Subject: Application # 6-04-088-A4 – Material Amendment for the San Diego Wetlands Restoration Project

MATERIAL AMENDMENT
STAFF REPORT AND PRELIMINARY RECOMMENDATION

Application No.: 6-04-088-A4

Proposed Amendment: Replacement of restoration module W45 with restoration module W16, modification of the timing for the construction of public beach accessways, and modifications to the special condition regarding a riverbank revetment.

EXHIBIT# 4
Page 1 of 1
Application Number: 6-04-088-A4
 California Coastal Commission

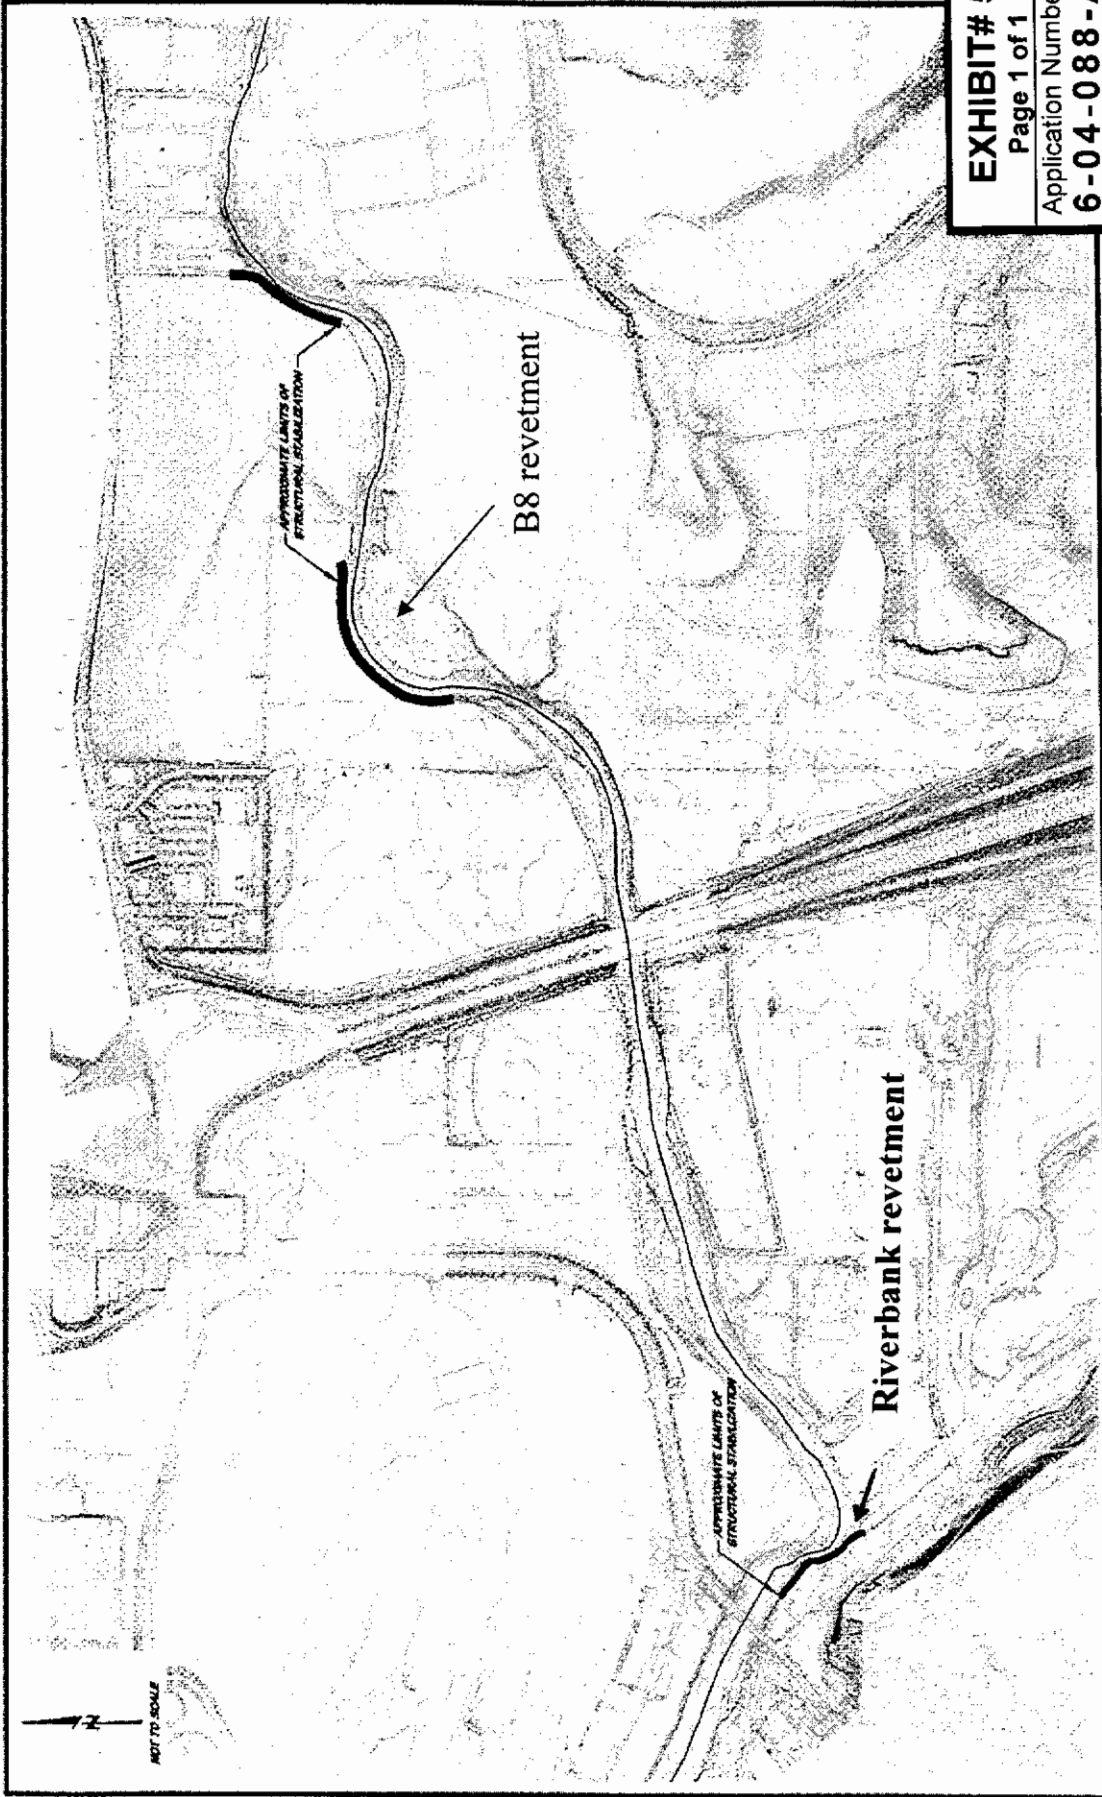
Restoration module W16 was included in the environmental documents for the FRP but was not required to be utilized to meet the mitigation requirements under CDP #6-04-088. Instead, W16 was proposed to be created as a mitigation bank of credits, called the Villages Mitigation Bank, to be used for future SCE projects. This amendment now proposes to use the majority of the wetlands created in restoration module W16 to replace the wetland creation mitigation formerly required to take place at W45, as W45 is no longer available,

and to mitigate the permanent impacts recently determined to exist on B8 (Exhibit 4). This replacement would allow for the applicant to meet the total mitigation acreages required under the approved FRP and CDP #6-04-88.

27. Villages Mitigation Bank. The wetland restoration as proposed on module W16 is approved in this Permit, and shall be used to replace mitigation requirements formerly intended to be fulfilled by module W45. Any remaining acreage not used to satisfy the mitigation requirements of this permit may be available as a part of a Villages Mitigation Bank should the applicant formally submit such a mitigation bank request in the future. However, the proposal to operate W16 as the Villages Wetlands Mitigation Bank, as more fully described in the *Villages Wetlands Mitigation Bank, Bank Enabling Instrument* prepared by SCE (January 2005), is not approved as part of this CDP application, nor is any mitigation credit that may accrue as a result of restoration of W16 approved at this time. To the extent that the Commission approves a final grading plan (pursuant to Special Condition #3) that includes excess acreage of restored wetlands on module W16 that is not required to comply with CDP No. 6-81-330-A, such excess acreage may be available in the future to satisfy some other wetland mitigation requirement if the use of module W16 as mitigation is authorized pursuant to a future coastal development permit. If module W16 is not fully restored concurrent with the disposal of excavated materials from the restoration project onto Disposal Site 32, an amendment to this CDP is required to revise the restoration plan to avoid or reduce disposal on existing wetlands in DS32.

EXHIBIT# 5
Page 1 of 1
Application Number: 6-04-088-A4
 California Coastal Commission

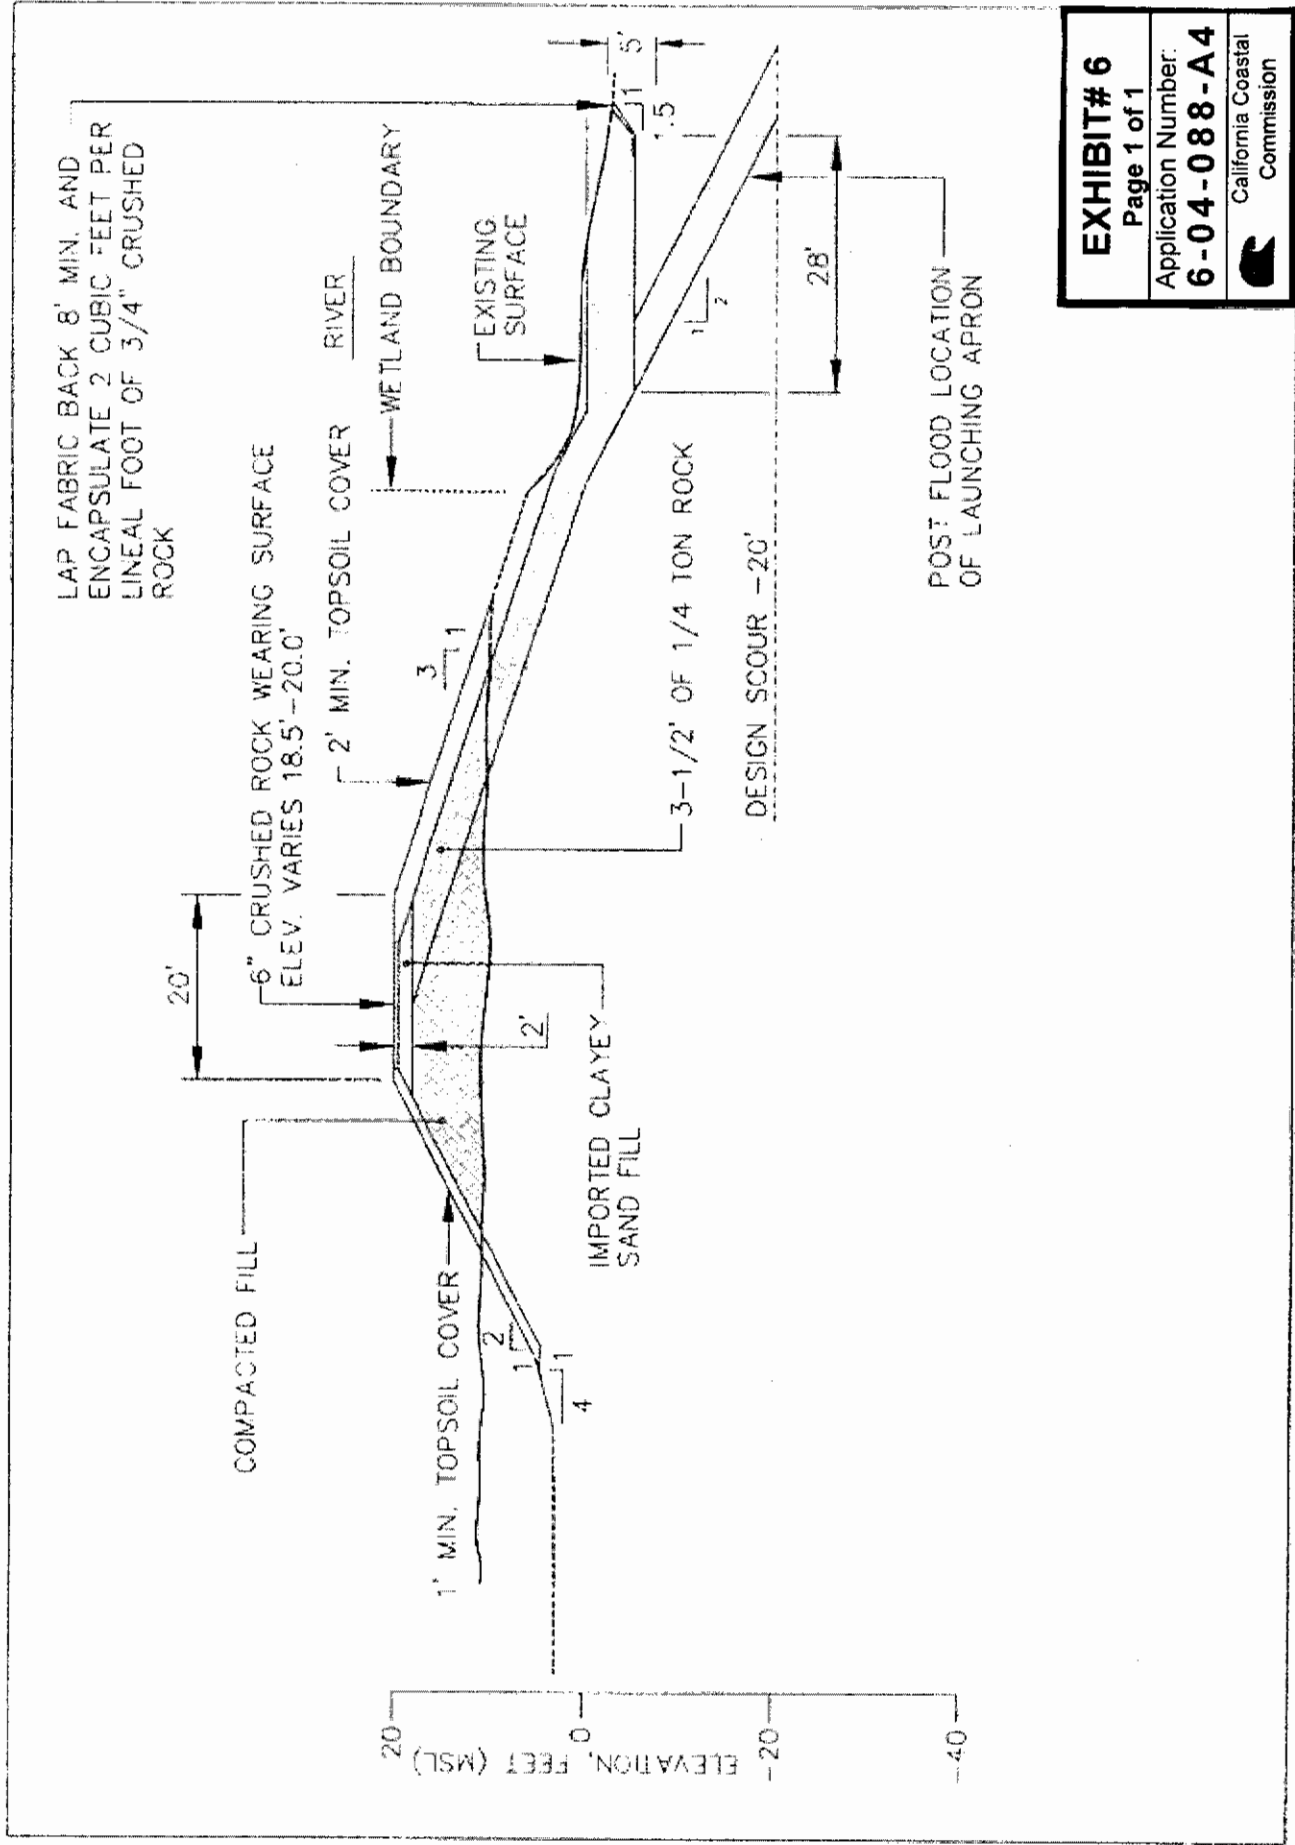
The first requested change to the permit involves the deletion of a requirement to apply a topsoil cover to the rock slope protection approved for the San Dieguito river bank located just east of Jimmy Durante Boulevard (Exhibit 5). The applicant's engineering team has raised concerns that applying topsoil to a revetment in this location would not be practical due to the potential for future scour and erosion. The applicant has submitted new, proposed site plans for the revetment that would locate the protective structure farther landward and reduce encroachment on the river channel (Exhibit 8). The current condition of the river bank in this location consists of an unengineered revetment constructed of rip rap, rail ties and other debris (Exhibit 9). The applicant proposes that removing existing debris and re-engineering the rock as a part of the new revetment construction would create a more uniform appearance, and when coupled with the landward shift of the revetment, would significantly reduce potential visual impacts that were addressed in the original condition language.

Coastal Development Permit 6-04-088 included the construction of a new riverbank revetment to be located just east of Jimmy Durante Boulevard along the southern river edge (Exhibit 5). This revetment would provide slope protection for a number of existing structures located along the river. The existing condition of the riverbank in this location consists of an area of unengineered fill comprised of rip rap, railroad ties and other assorted debris (Exhibit 9). This deteriorating revetment affords some protection from flooding, erosion and scour to the existing structures located just southward. The original permit required that topsoil be applied and maintained on exposed portions of any newly constructed revetment in order to mitigate for any potential visual impacts to public use areas.

Engineers for the applicant have expressed concerns that topsoil placed on top of any revetment in this location would not be permanent and would likely erode away quickly due to run-off and scour patterns in this area. Therefore, the applicant is proposing to delete this requirement from the permit. At the direction of Commission staff, the applicant has shifted the location of the new revetment landward and reduced its overall footprint in an effort to decrease encroachment into the river channel, and to reduce potential visual impacts (Exhibit 8). The suggested modifications to **Special Condition #4** would memorialize these proposed changes through a reference to this Exhibit (8). The updated site plan also describes a revetment with a reduced linear footprint, with the proposed new revetment extending along approximately 550 feet of river bank, compared to the approximately 600 foot revetment previously approved as a part of CDP 6-04-088. The applicant further asserts that by removing the existing unengineered debris pile, the newly constructed revetment would have a more uniform appearance, resulting in an aesthetic improvement over existing conditions. The combination of all of these proposed refinements to the original revetment design, including a landward shift of the revetment away from public viewing areas, a reduction in the ultimate size of the proposed structure, and the removal of the existing debris would result in an improved visual experience for the public, as was intended through the original condition language that required the placement of topsoil on the exposed revetment surfaces. The revised riverbank revetment plans will still require final Executive Director review to ensure that they are in general conformance with the original plans approved as a part of the FRP, and would therefore provide the necessary protection for upland developments and the riverbank itself required as a part of CDP 6-04-088.

4. Berm and Slope Protection. ~~PRIOR TO THE COMMENCEMENT OF CONSTRUCTION OF THE REVETMENT~~, the applicants shall submit to the Executive Director for review and written approval, final plans for berm and slope protection for the San Dieguito Wetlands Restoration Project that have been approved by the City of Del Mar and the City of San Diego. Said plans shall be in substantial conformance with the two sets of plans submitted June 20, 2005, (City of Del Mar Sheets 33-35, dated 6/17/05, and City of San Diego Sheets 67-72, dated 5/26/05), and as further detailed in the submitted site plan received May 10, 2010 attached as Exhibit 8 to this report (6-04-088-A4), and shall include the following:

- a. Detailed plans shall address the transitional area between the adjacent slopes and proposed berm protection and the revetment on the south side of the river east of Jimmy Durante Boulevard. The rock shall be placed to minimize erosion and disruption of the adjacent slopes.

- ~~b. The proposed topsoil cover to the rock slope protection shall be installed immediately following completion of construction and continually maintained to mitigate the visual impact of the rock slope protection to public use areas.~~
